NORTH KOBES
c-97-G / 94-B-9
DEHYDRATION SKID
P & ID

NORTH KOBES
c-97-G / 94-B-9
DEHYDRATION SKID (REBOILER)
P & ID

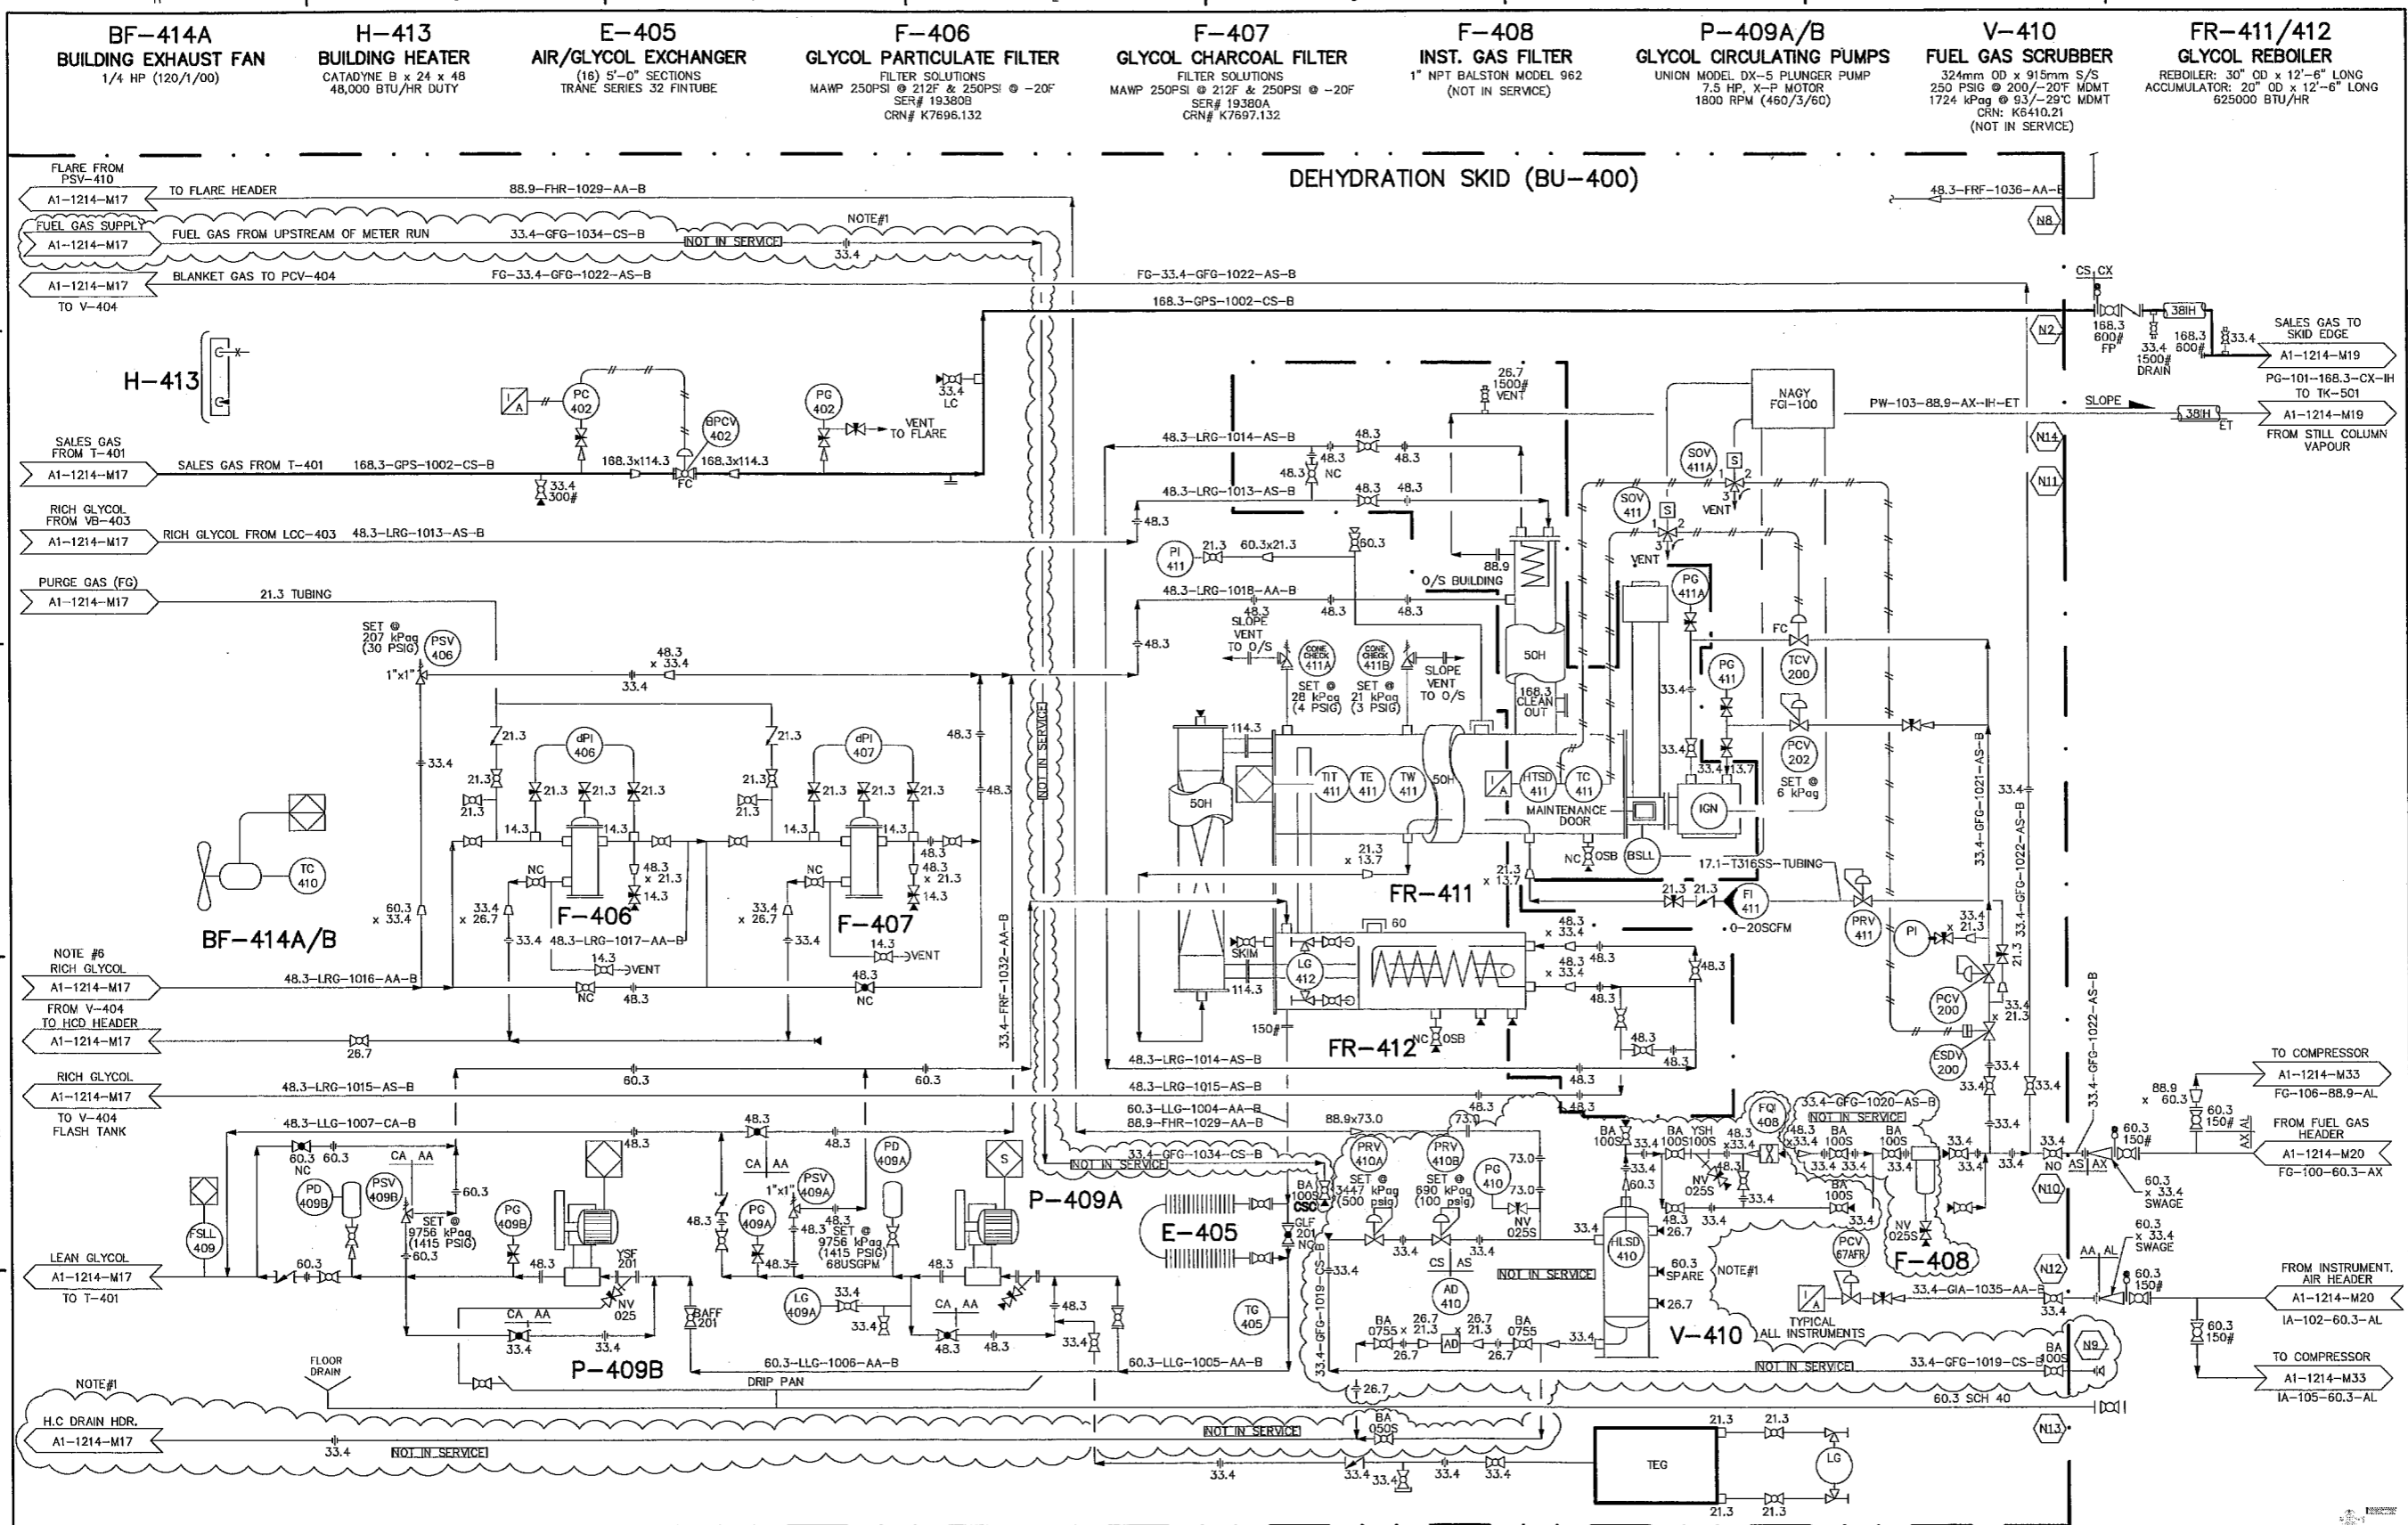
NOTE#1: EXISTING IN BUILDING, NOT IN SERVICE
